RE: ADDITIONAL COMMENTS ON THE INTEGRATED ENVIRONMENTAL MONITORING STATUS REPORT FOR THIRD QUARTER 1999

ADDITIONAL OHIO EPA COMMENTS ON THE INTEGRATED ENVIRONMENTAL MONITORING STATUS REPORT FOR THIRD QUARTER 1999

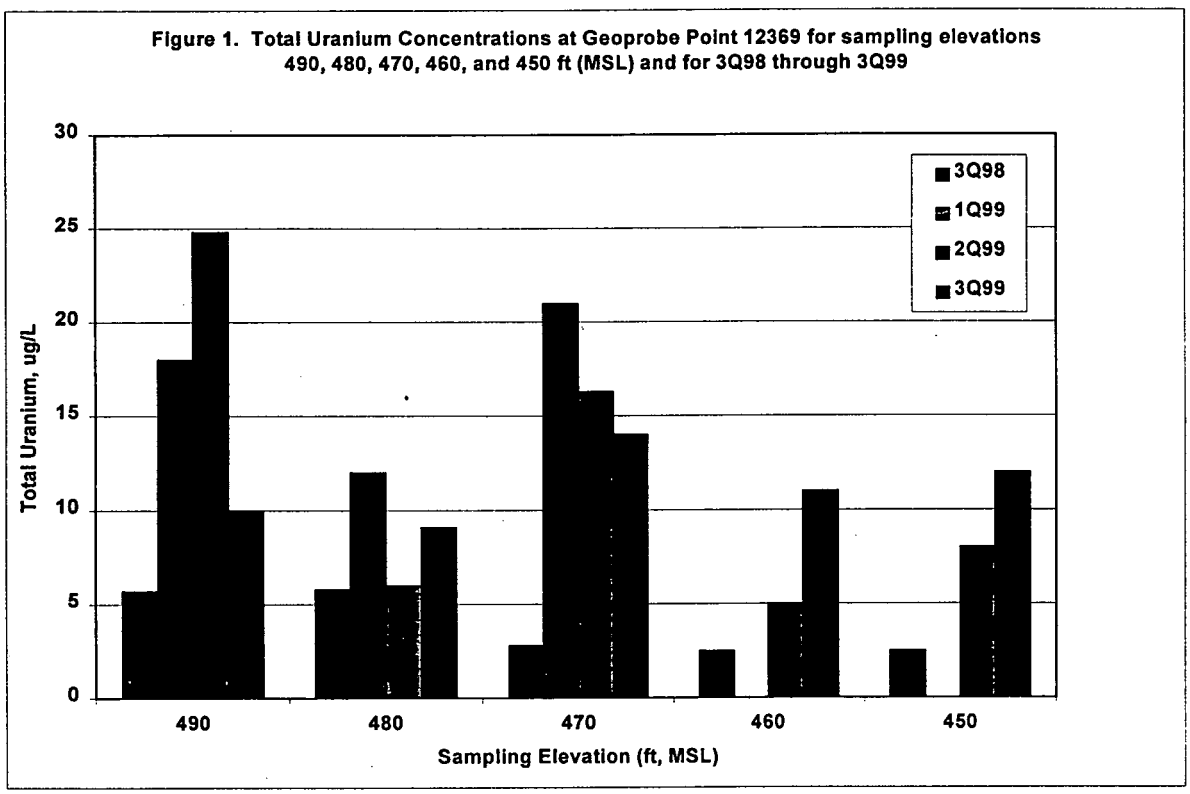
4. Commenting Organization: OEPA Commentor: HSI GeoTrans, Inc.
Section #: 1.0 Pg.#: 1-4 Line #: 5 Code: C
Original Comment #:
Comment: Concentrations for sampling elevations 460 and 450 ft (MSL) at Geoprobe Point 12369 appear to be increasing since the beginning of re-injection operations (Figure 1). Although only three data points are available, the increase is present at both sampling levels and may indicate southward migration of the total uranium plume beneath the re-injection zone. The observed increases suggest that one year of Geoprobe sampling may not be sufficient for fully understanding the effects of re-injection on plume migration patterns. Should the Geoprobe sampling

be continued (perhaps on a less frequent schedule) in order to assess if the observed trend is significant?
